Introduction On some ECHO, Scion xA, and Scion xB vehicles, a condition may exist that allows the evaporator drain hose to become detached, causing the passenger foot well to become wet. This bulletin provides a procedure to correct this condition.

- Applicable Vehicles**
- **2003 – 2005** model year **ECHO** vehicles produced **BEFORE** the Production Change Effective VIN shown below.
 - **2004 – 2006** model year **Scion xA** and **xB** vehicles produced **BEFORE** the Production Change Effective VINs shown below.

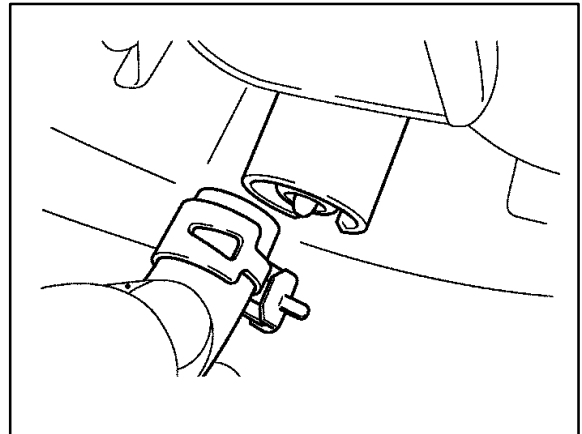
1. Inspect the evaporator drain hose to ensure that it is the cause of the water leak. If the evaporator hose is out of position, continue with this procedure.

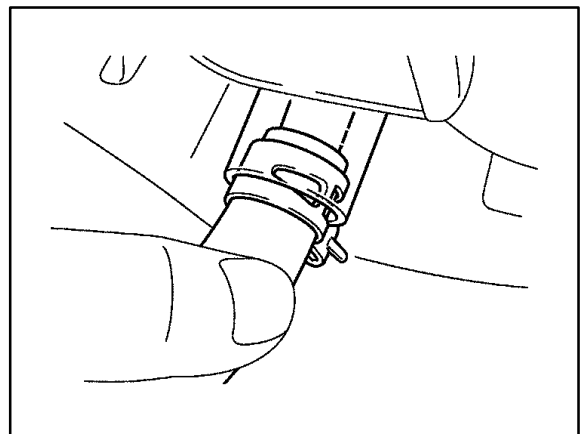
2. Install the retaining clamp on the drain hose.

3. Push the drain hose up onto the evaporator drain tube. Ensure that the drain hose is up far enough for the retaining clamp to fully engage the tube.
